Tech Bulletin - GT Boom Shortening

Shortening the GT boom will accommodate riders with an x-seam range of 36"- 45". Follow the steps below to shorten your stock GT boom.

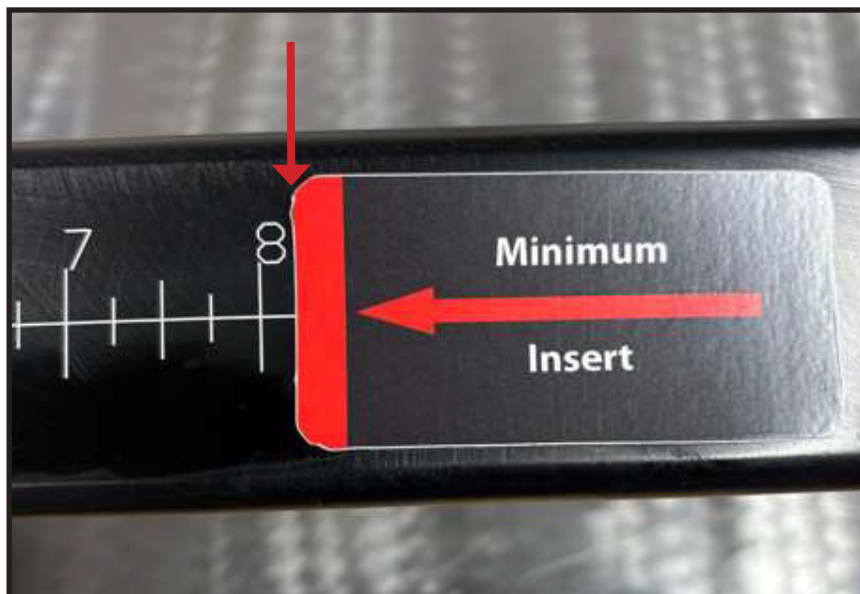
Clean and dry the boom. Once dry, place the sticker as shown below. The new minimum insert (edge of sticker) should align with the right side of the "8" without covering it.
